Project	IEEE 802.16 Broadband Wireless Access Working Group < http://ieee802.org/16 >	
Title	Transparent zone and PRBS ID	
Date Submitted	2007-5-08	
Source(s)	Michiharu Nakamura Fujitsu Laboratories LTD 5-5, Hikarinooka Yokosuka, Japan. 239-0847 Dorin Viorel Fujitsu Microelectronics Canada Inc. Mike Hart Fujitsu Laboratories Europe	Voice: +81-46-839-5371 Fax: +81-46-839-5560 Email: michi@labs.fujitsu.com Voice: +1 403 207 6334; chuo@fmci.fujitsu.com Voice: +44 20 86064523; mike.hart@uk.fujitsu.com
Re:	Call for Technical Proposals regarding IEEE Project P802.16j (IEEE 802.16j-07/007r2)	
Abstract	This contribution proposes a procedure for handling retransmission of downlink HARQ for transparent RS.	
Purpose	Add proposed spec changes in P802.16j Baseline Document	
Notice	This document has been prepared to assist IEEE 802.16. It is offered as a basis for discussion and is not binding on the contributing individual(s) or organization(s). The material in this document is subject to change in form and content after further study. The contributor(s) reserve(s) the right to add, amend or withdraw material contained herein.

Transparent Zone and PRBS ID

Figure 1 Problem statement

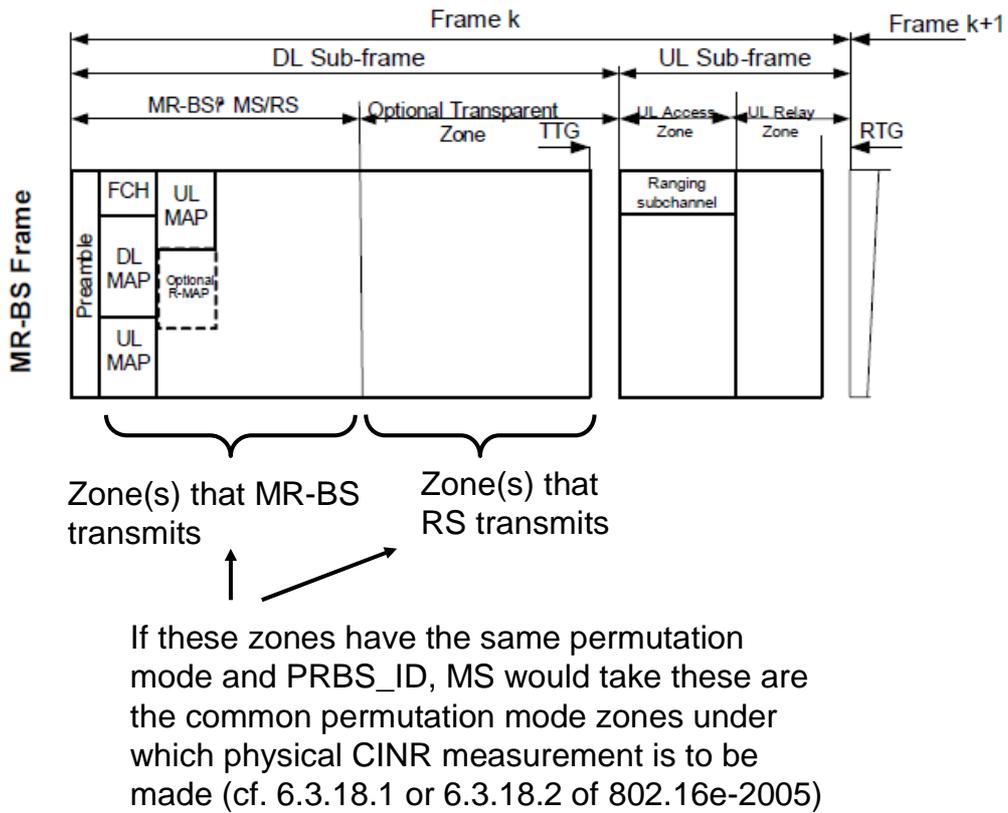
In transparent mode relay, in case relay link and access link have common permutation mode with the same PRBS_ID, MS would take it as a common permutation mode zone(s) under which physical CINR measurement is to be made. When these zones include both a transmission from MR-BS and a transmission from RS, hence, physical CINR measurement of a specific permutation would be improperly calculated at a MS.

Figure 2 Proposed resolution

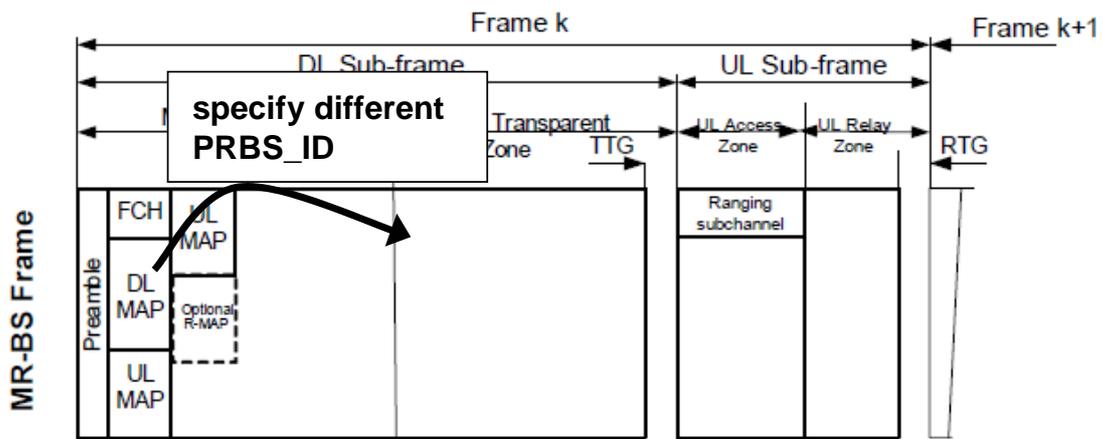
To specify different PRBS_ID for the zones used for the transmission from MR-BS and from RS.

The DL sub-frame shall include at least one zone for MR-BS to its subordinate MS/RS transmissions and may optionally include a transparent zone for RS to its subordinate stations transmissions. Optionally the MR-BS may transmit in the transparent zone as well. The transparent zone can be indicated by STC_DL_ZONE_IE() defined in Table 279. The transparent zone should be specified with different PRBS_ID from the zone that MR-BS transmits. The UL sub-frame may include a zone for MS to its access station transmissions and optionally include a zone for RS to its access station transmissions
